Sierrita Operations
Environment, Land & Water Department
6200 West Duval Mine Road
PO Box 527
Green Valley, Arizona 85622-0527

May 23, 2014

**Re: Response to Comments, Voluntary Remediation
Groundwater Investigation Report Freeport-McMoRan
Sierrita Mine Green Valley, Arizona; Site Code: 100073-03**

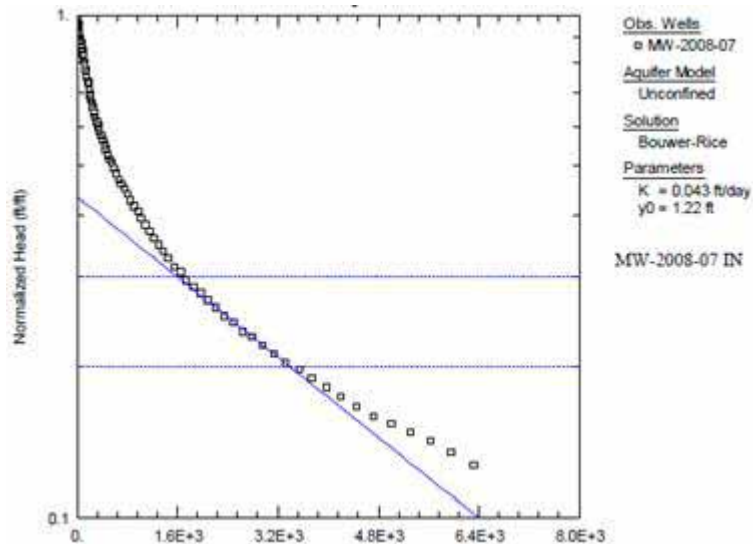
11. **ADEQ Comment:** Tables 6 and 7: VRP requests that Sierrita provide an example for calculating vertical gradients and slug test results. This will assist VRP in confirming the method used and the outcome of the calculations.

The Bouwer-Rice solution is an empirical relationship describing the water-level response in an unconfined aquifer due to the instantaneous injection or withdrawal of water from a well and is presented as the following equation:

An example of the calculation process is presented in the graph below for MW-2008-07. In this example, the data were plotted (open circles) and a corresponding matching line (solid blue line) was fitted to the data. The data was matched within the recommended head range (Butler, 1998), as shown by the two horizontal blue dotted lines.

Figure 1. Piper diagram for background wells and select monitoring wells at the Sierrita mine. Data points are grouped and labeled.

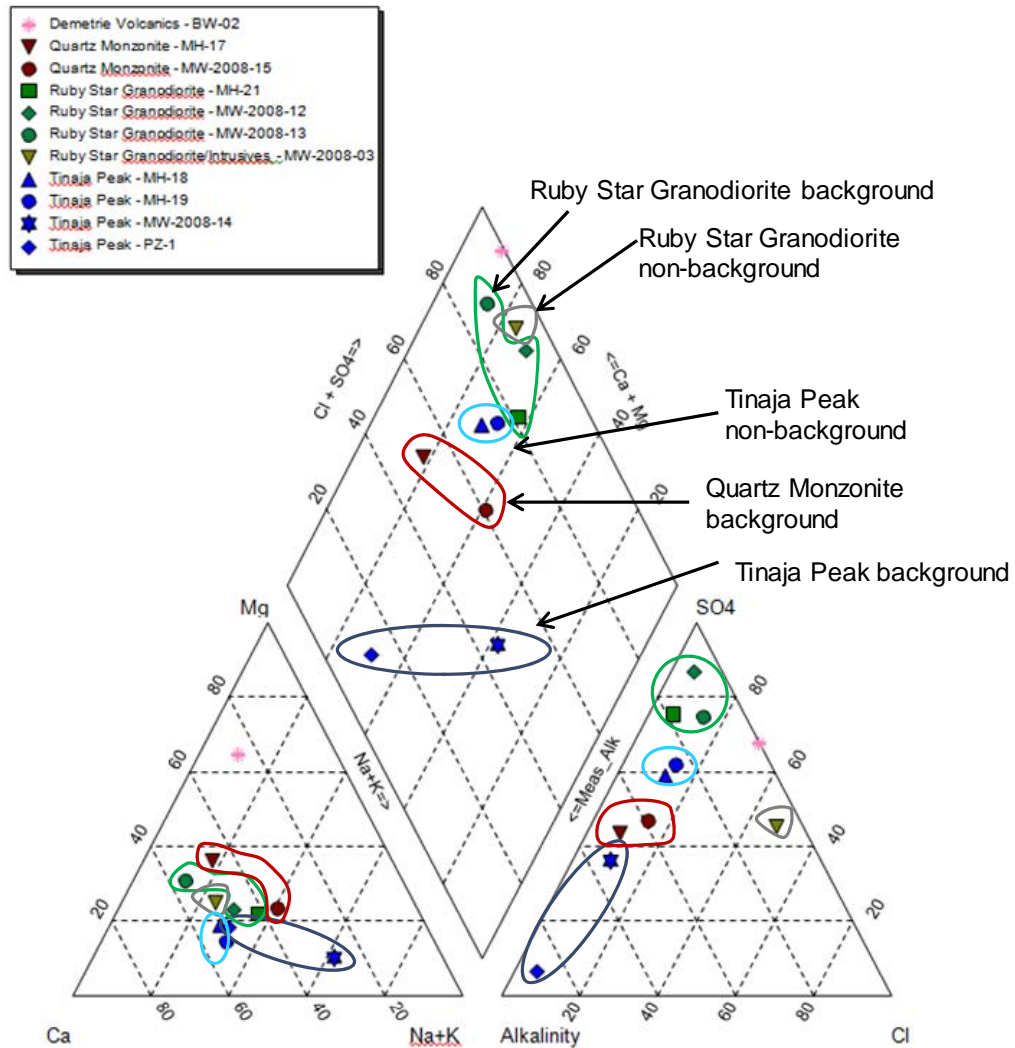
16. **ADEQ Comment:** *Figures 11 through 14: VRP notes that the groundwater contours depicted on the potentiometric maps refer to wells MH-21, MW-2008-12, MW-2008-13, MH-17, MW-2008-14, MW-2008-15, and PZ-01 as "background wells". VRP does not completely agree that these wells are adequate to provide a true representation of background water quality. Only MW-2008-12 is shown to be upgradient of Sierrita mining operations and/or disturbed ground. However, VRP notes that MW-2008-12 could be hydraulically downgradient of the Twin Buttes mine site and therefore may not actually represent true background..*

As mentioned in ADEQ comment #10, Piper and Stiff diagrams can be useful to assess groundwater geochemistry and to classify waters according to major cation and anion chemistry. Figure 1 (below) provides a Piper diagram for background wells in the Ruby Star Granodiorite, Harris Ranch Quartz monzonite, and Tinaja Peak formation, as well as non-background locations.

As shown in Figure 1, the 3 wells in the Ruby Star Granodiorite which are in the North Background area group together in terms of major cation and anion composition, whereas a downgradient well screened in Ruby Star Granodiorite (MW-2008-03) has a very different anion composition from the background wells. Similarly, as shown in Figure 1, the Tinaja Peak background wells (PZ-1 and MW-2008-14) are both of similar major cation and anion composition, and differ in composition from those wells that are downgradient of mine facilities that are also screened in the Tinaja Peak formation (MH-18 and MH-19).

This figure also demonstrates that the Tinaja Peak background wells (PZ-1 and MW-2008- 14) are both of similar major cation and anion composition and differ in composition from those wells that are downgradient of mine facilities in the Tinaja Peak formation (MH-18 and MH-19).

SITE LOCATION MAP

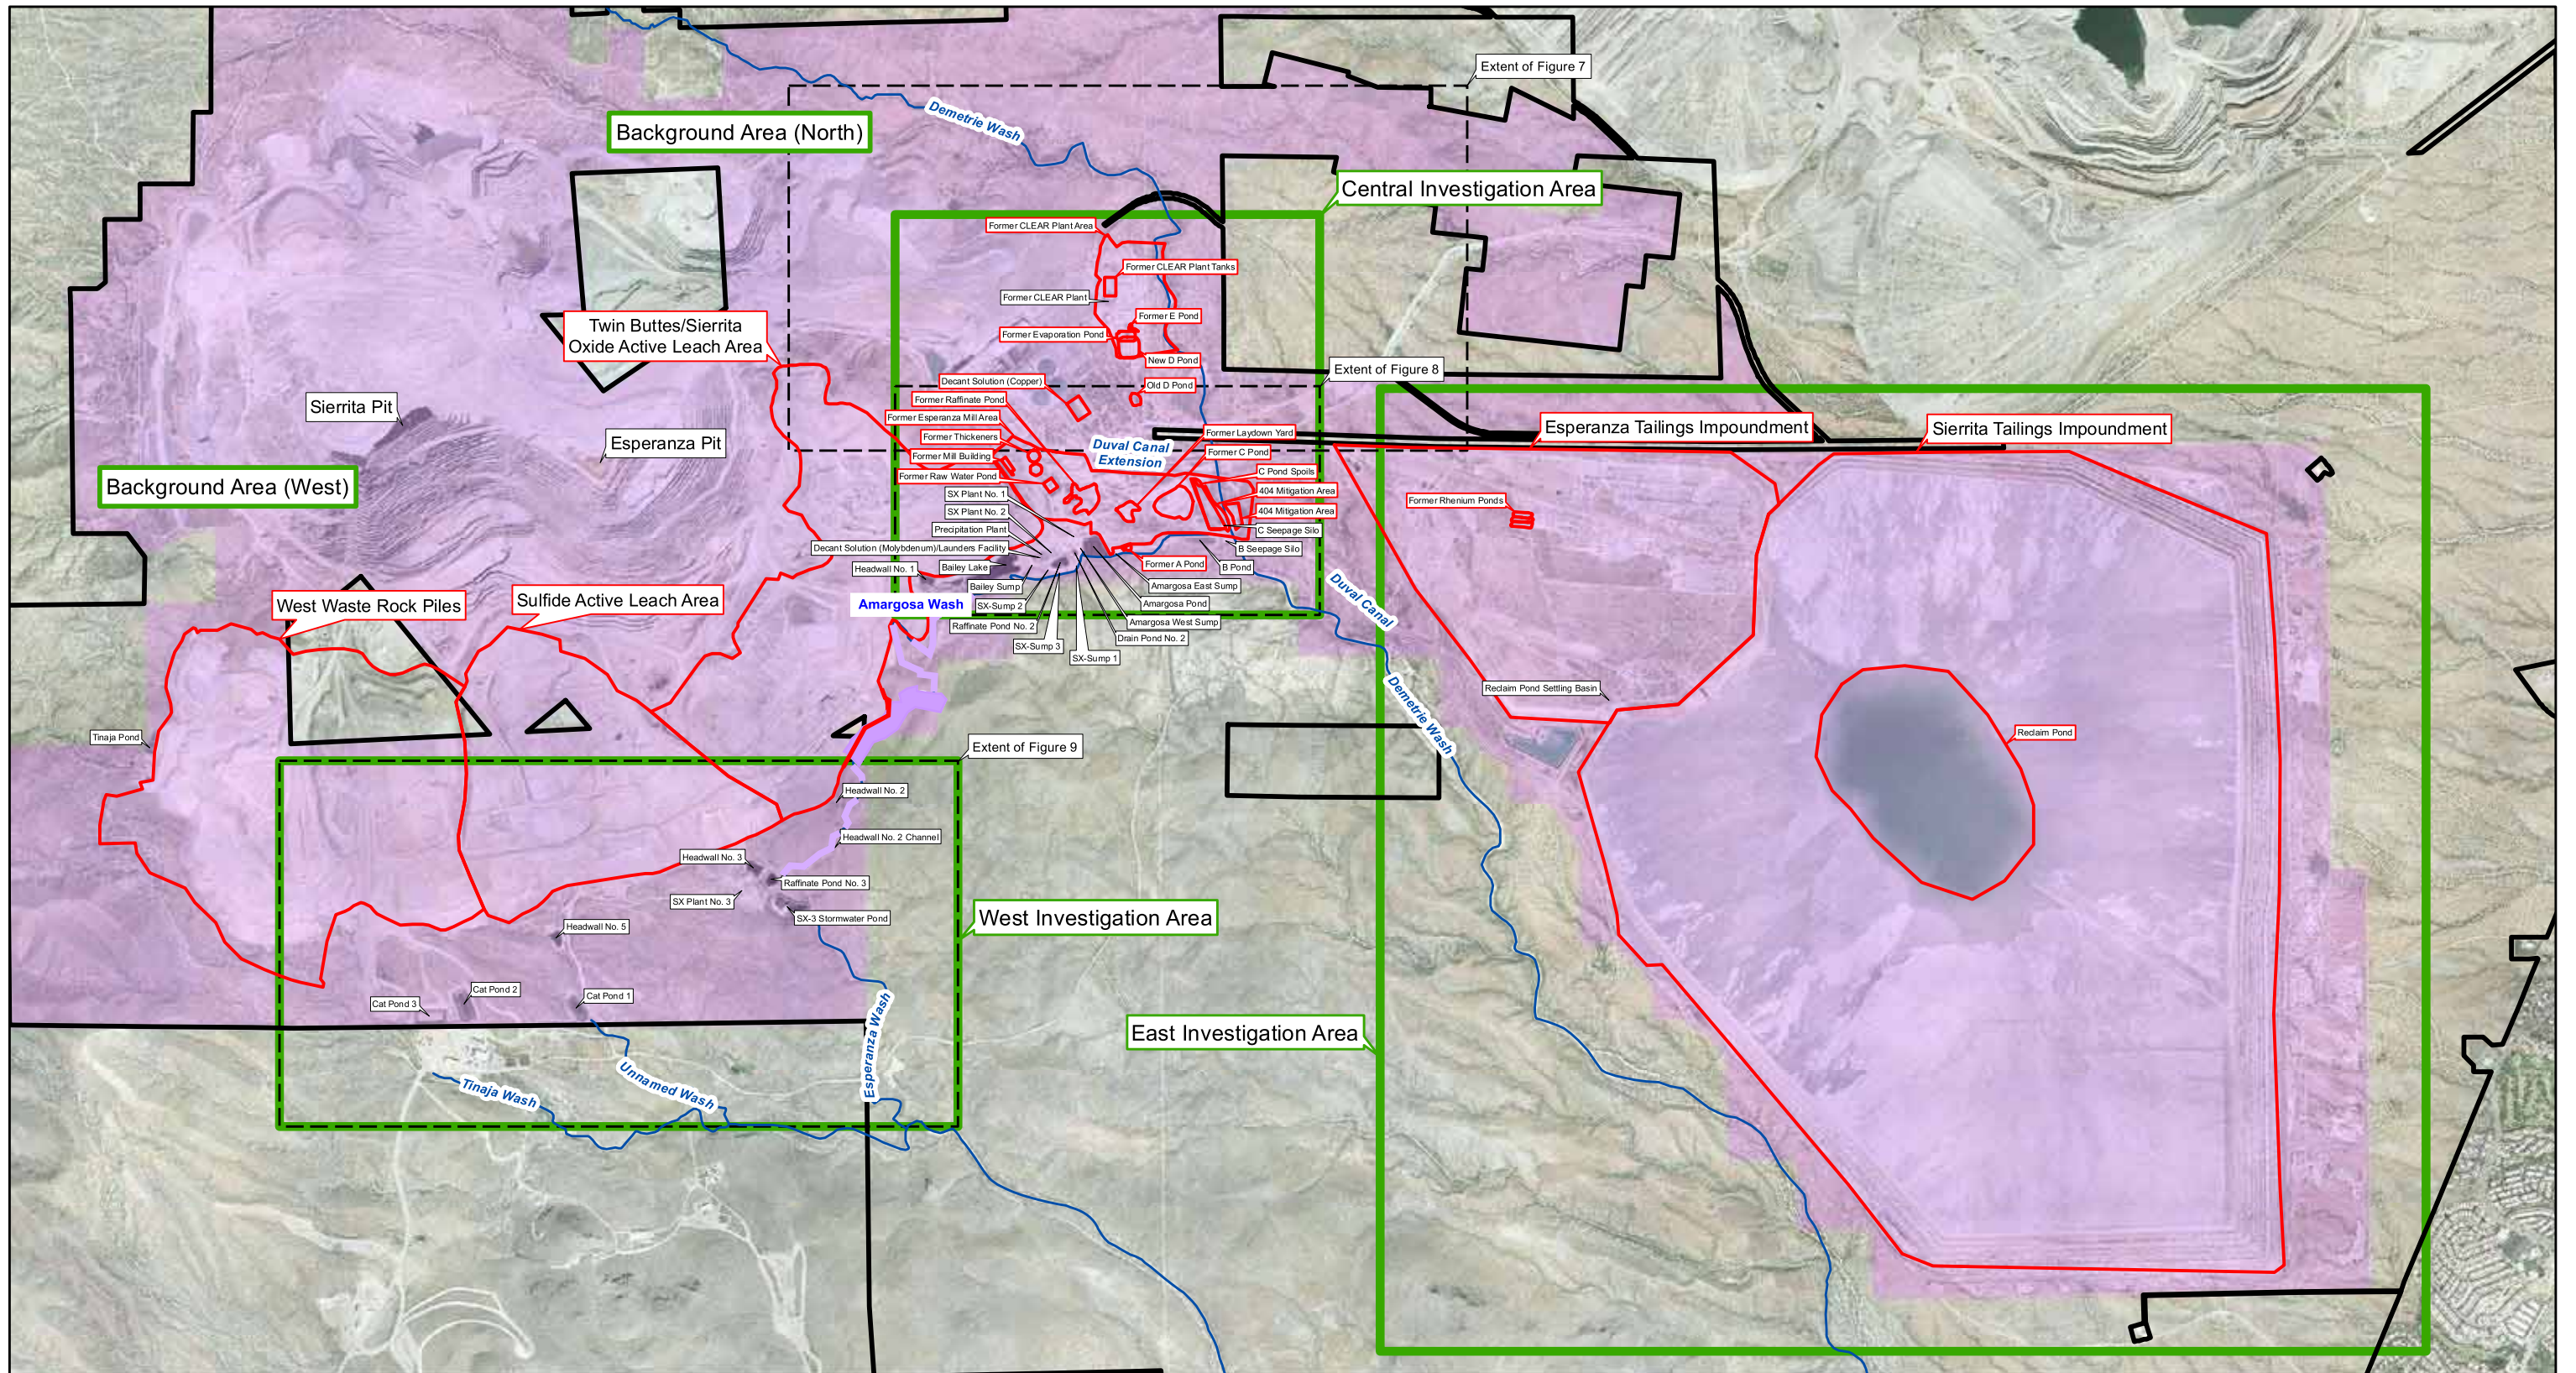
13. **ADEQ Comment:** *Figure 2: VRP requests that Figure 2 be updated to include current Sierrita property boundaries, an outline of each wash, delineation of each investigation area and respective operations, and an outline of lined canals, trenches, and washes.*

Sierrita Response: Please see attached replacement Figures 1 and 2 (Attachment 2). Figure 1 shows the Sierrita property and VRP Site boundaries (these could not be fit in their entirety into Figure 2, so Figure 1 was revised accordingly). Figure 2 now includes outlines of each wash, delineation of each investigation area, and portions of the VRP Site boundary and property boundary as can be seen at this resolution. Major and minor operating components of the mine were identified in Figure 2 and some labels have been revised to more clearly label each feature. Outlines of lined canals and channels have been provided in Figure 8 and 9, respectively. The interceptor sump and trench systems at the Site is small relative to the scale of other features; hence these features are labeled but not outlined in the figures, and are described in the text of the report.

**FACILITIES AND SAMPLING LOCATIONS
LOWER DEMETRIE WASH AND AMARGOSA WASH**

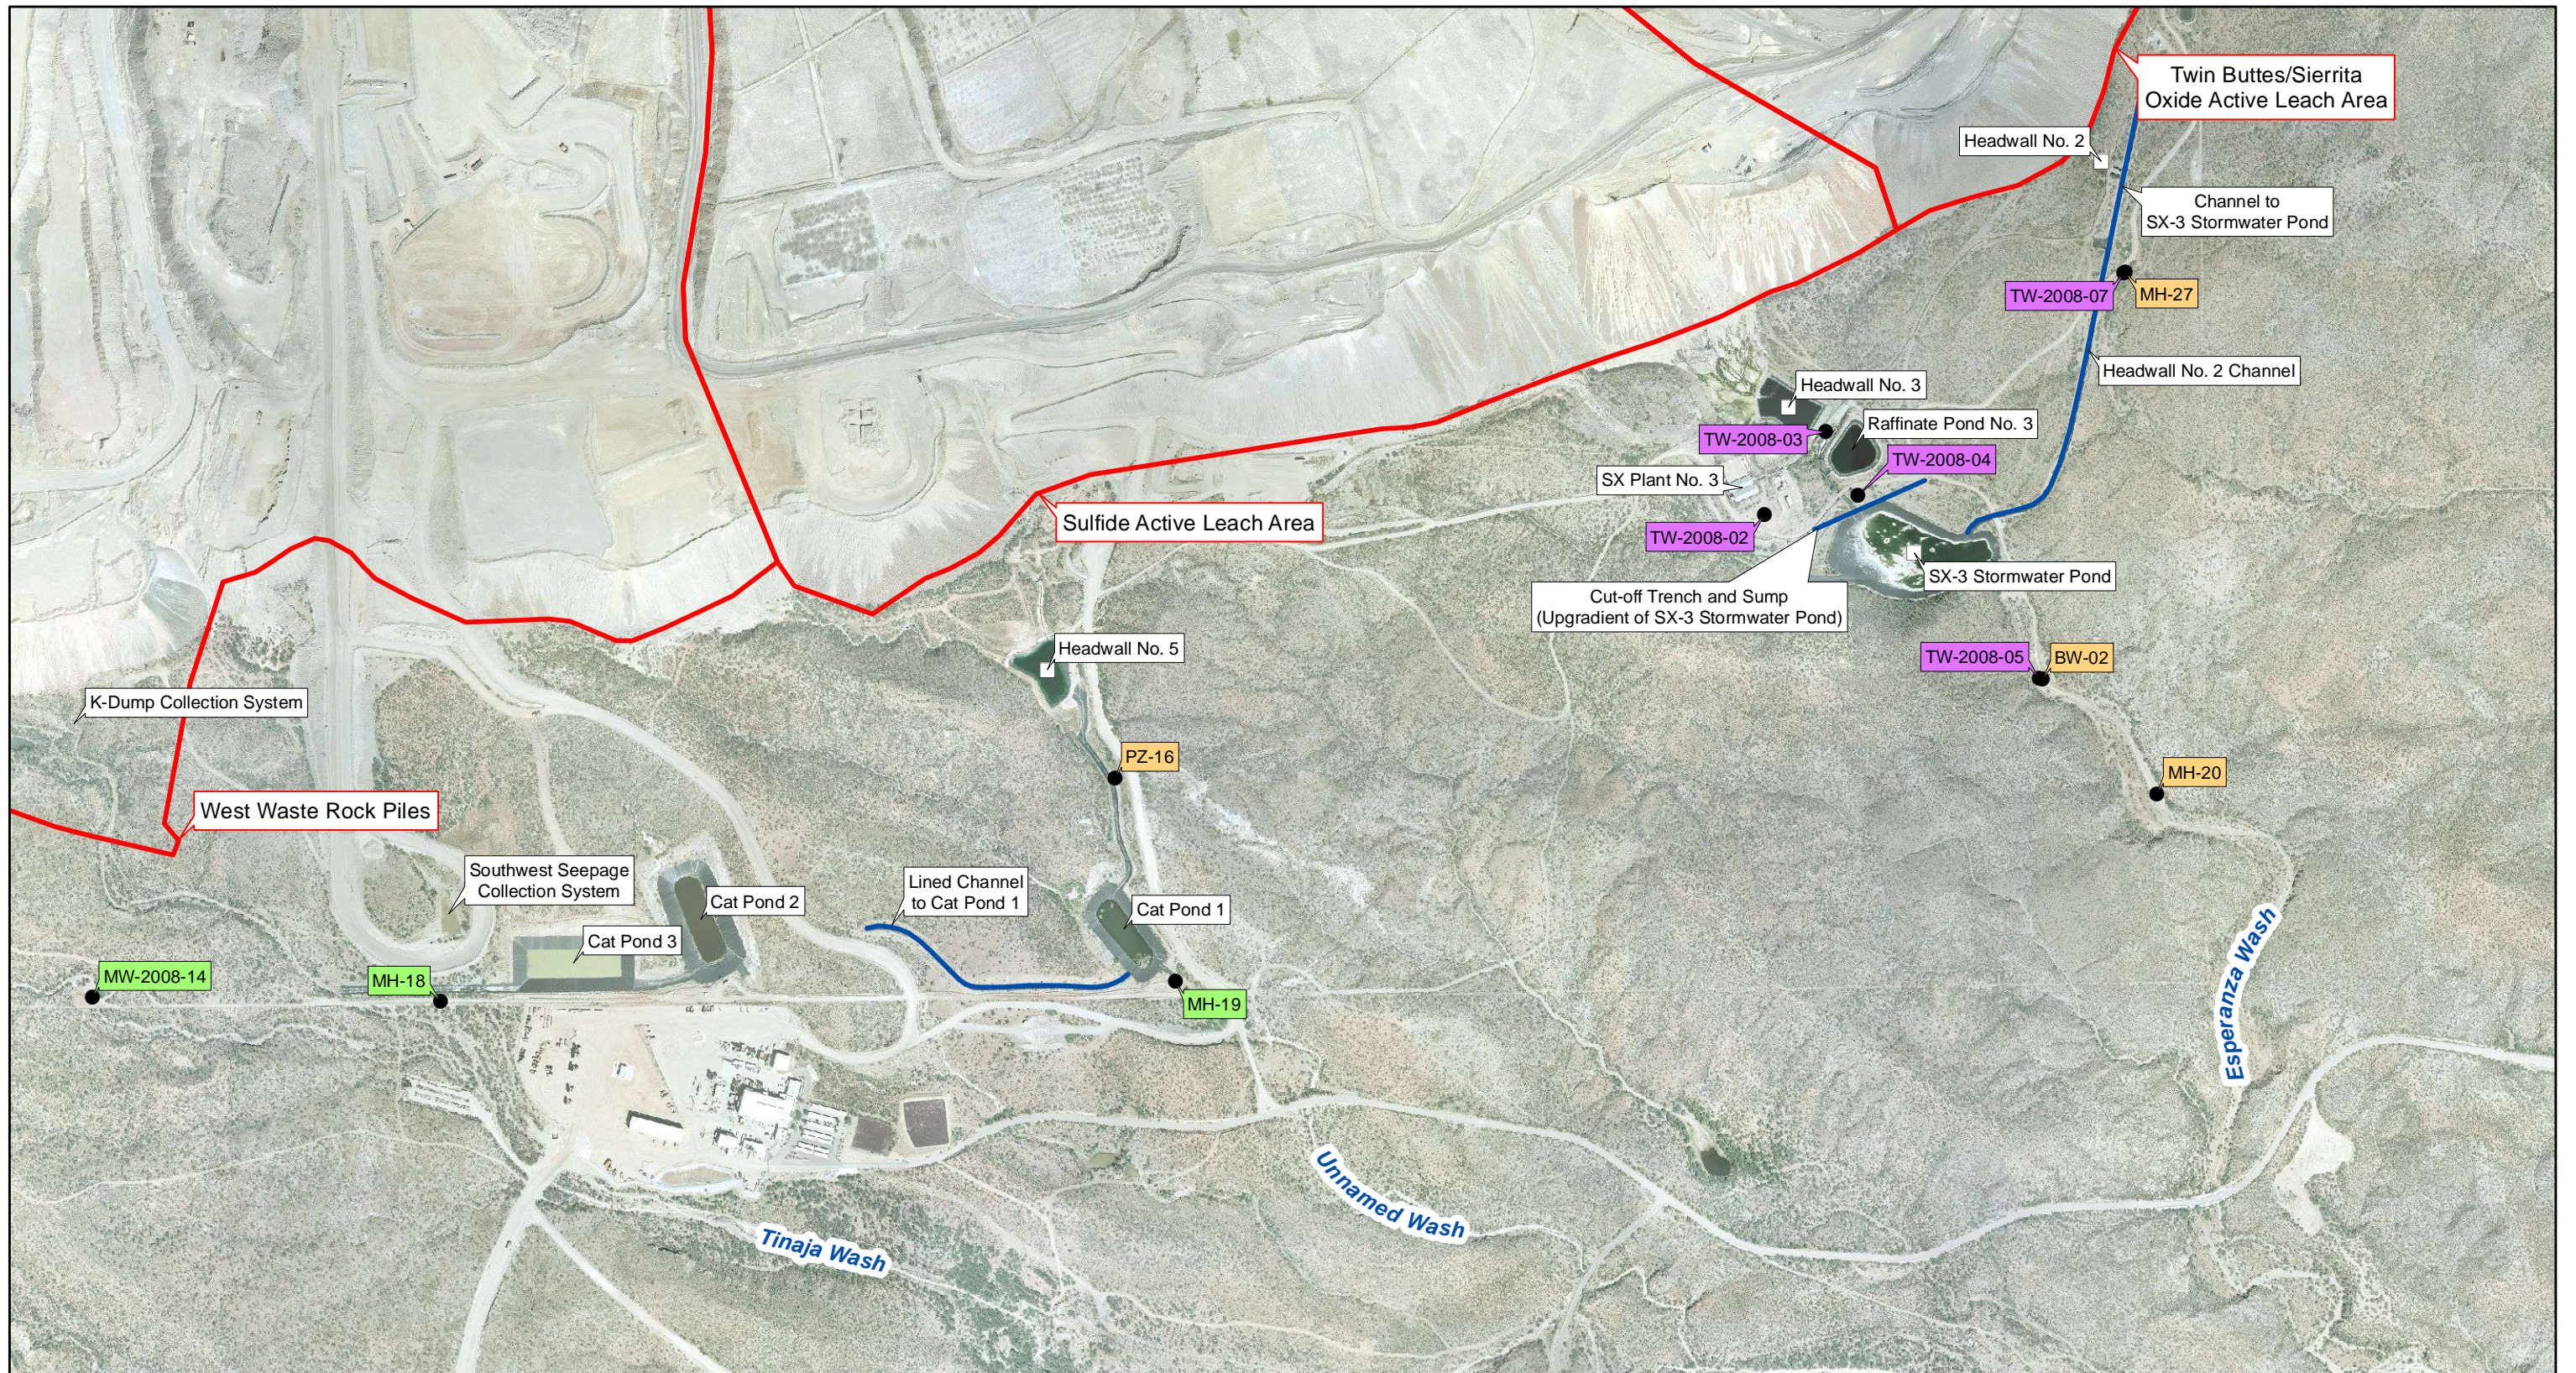
7. **ADEQ Comment:** Page 18, Section 2.6.2.8 "Sump and Interceptor Trench System":

a. Please clarify if the 160 gallons per minute recovered by the LCRS is thought to be the entire volume of leakage from Raffinate Pond No. 2. If so, what is the evidence that supports that conclusion?

b. Please explain the nature of the "underflow" that is captured by such engineering controls as SX-Sump 1, SX-Sump 2, SX-Sump 3, Amargosa East Sump, Amargosa West Sump, and the interceptor trenches.

Sierrita Response: (a) The description of the LCRS will be revised, removing the reference as to the rate of recovery, which was incorrectly stated. The LCRS is designed to prevent leakage rates that exceed facility-specific Action Leakage Rates (ALRs) or Rapid and Large Leakage Rates (RLLs), which vary between 28 and 35,932 gallons per day depending on the type of facility. In addition, the last sentence in paragraph four, Page 18, Section 2.6.2.8 will be removed. Please see the attached replacement page (Attachment 2) for Page 18 of the Report.

(b) The "underflow" that is captured by the sump and interceptor trench systems is subsurface flow and potential seepage from Headwall 1 and Bailey Lake, unlined active permitted APP pregnant leach solution impoundments, and potentially from Raffinate Pond No. 2, a double-lined active permitted APP leach solution impoundment with LCRS. For clarification, APP descriptions of the components of the sump and interceptor trench system include:
